Craig Y Perthi Solar Farm Resubmission

Appendix 1.1 Newport City Council Pre- Application Response

25 January 2022

PROPOSAL: PRE-APPLICATION PLANNING ENQUIRY FOR A
PROPOSED SOLAR FARM, BATTERY STORAGE,
WILDLIFE ENHANCEMENT AREA AND ANCILLARY
DEVELOPMENT
SITE: Land south of Castle Farm, Bishton, Newport
APPLICATION TYPE: Pre-app Stat Enquiry

CNC/NRW Development Advice Map, Accessed (31.01.2022)

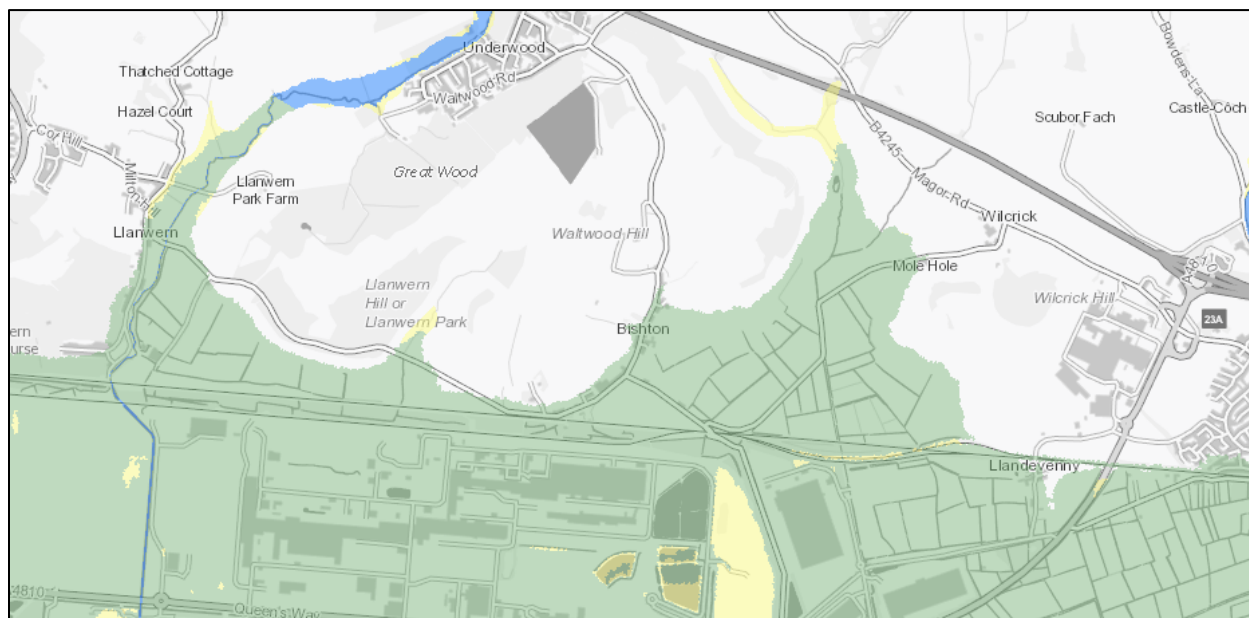
Significant parts of the site lie in areas within defended floodplains, green on the plan extract below. These include areas identified for solar arrays and for the sub-station.

The position regarding the substation / grid connection yard (battery storage area?) is more opaque and could be classed as highly vulnerable development (power stations). Some consideration should be given to this issue in any submitted application.

In terms of run-off the site will remain primarily grassed and the impacts of run-off from the panels should be minimal. However any areas of significant hard standing such as access tracks and the grid yard may need some attenuation measures and consideration of run-off and means to deal with it should form part of any submission.

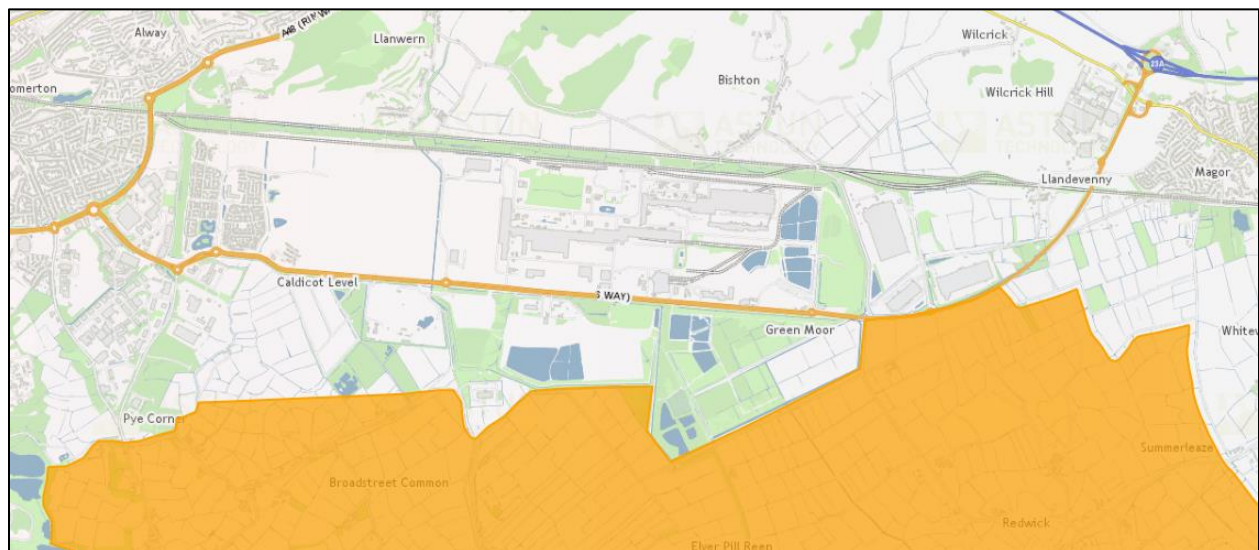
I would suggest some consideration is given to long views from the seawall over the Gwent Levels Special landscape Area from the All Wales Coastal Path and the likely impact on amenity of users of that important route.

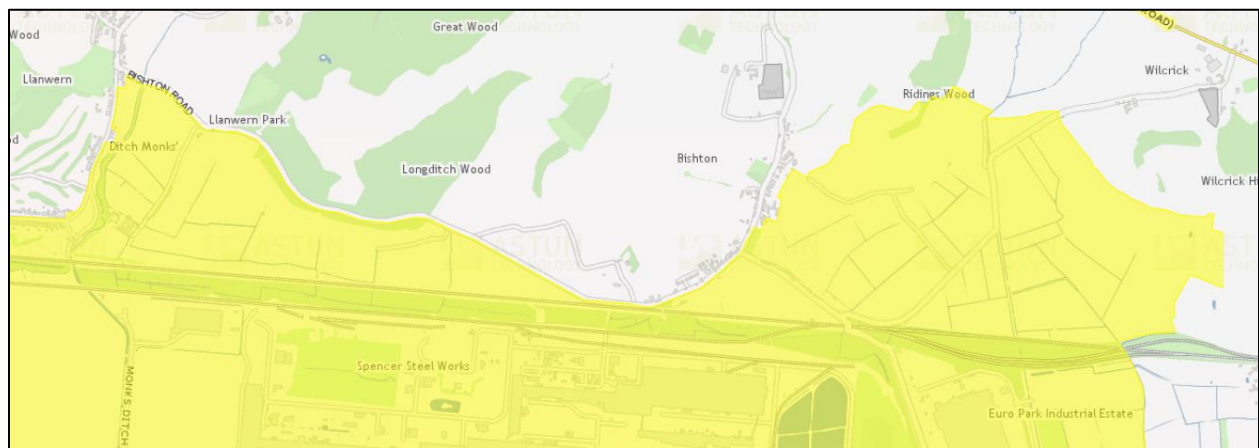
Several Public Rights of Way (PRoW) cross the site. Under a simple assessment these should be maintained.

However I would suggest some consideration be given to a rationalisation of these routes if this would give an improved user experience, for example allowing wider corridors less hemmed in by solar arrays and a reduction in the levels of fencing required to secure the arrays.

The LVIA should consider the impact on users of these routes.

Llanwern Park – Historic Park & Garden & Bishton Castle Scheduled Monument (iShare Extract)

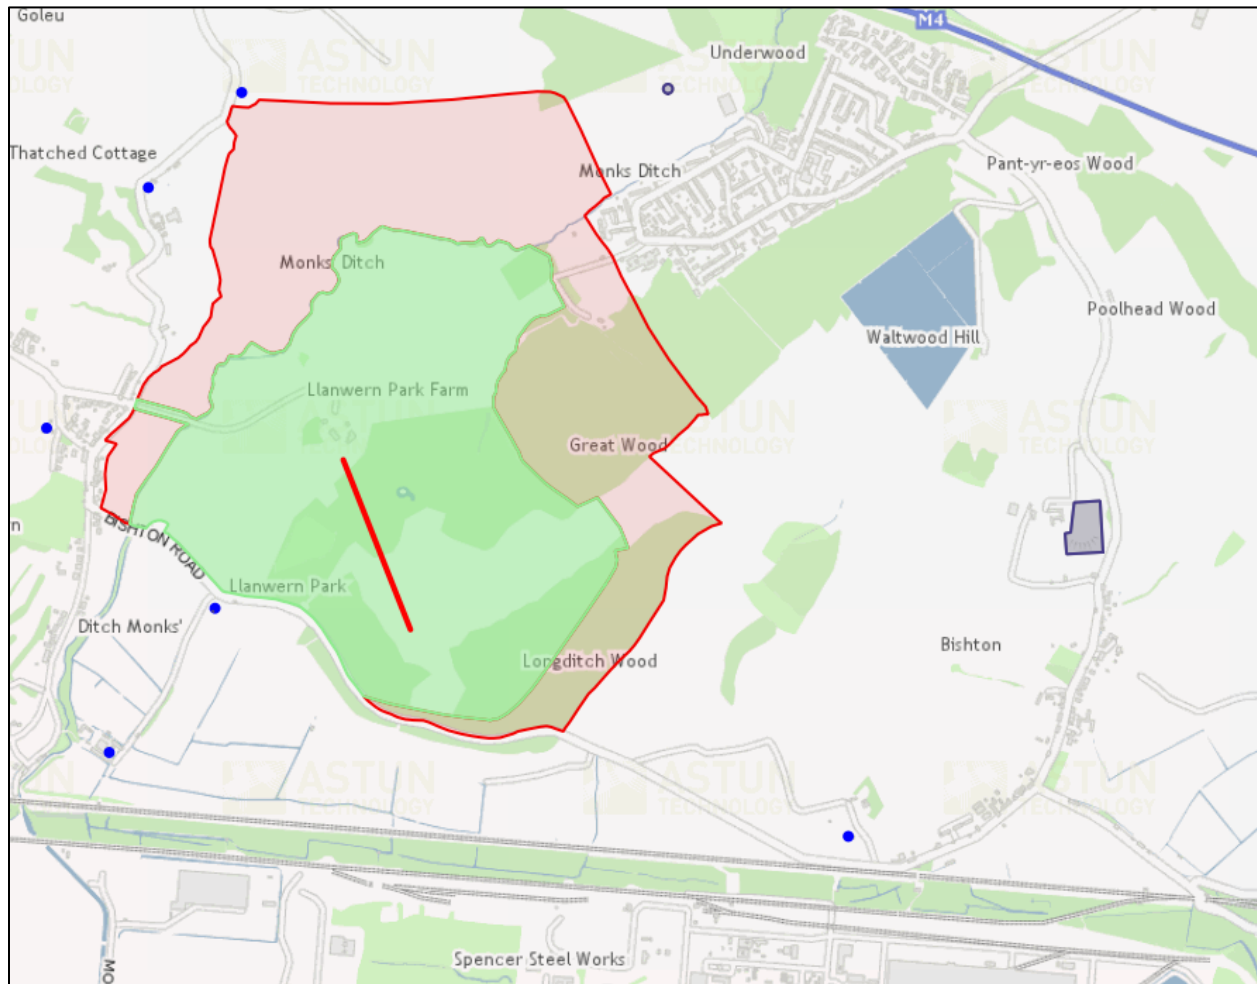
The proposal is likely to have a significant impact on Llanwern Park, see [Llanwern Park, Garden, Llawern | Coflein](#)

The proposal will have direct impact on the Park and will affect key views of the site, note dark red line on the plan extract above. All of these should be carefully assessed.

The proposal will impact on the setting the Bishton Castle Scheduled Monument (MM128). This should be assessed.
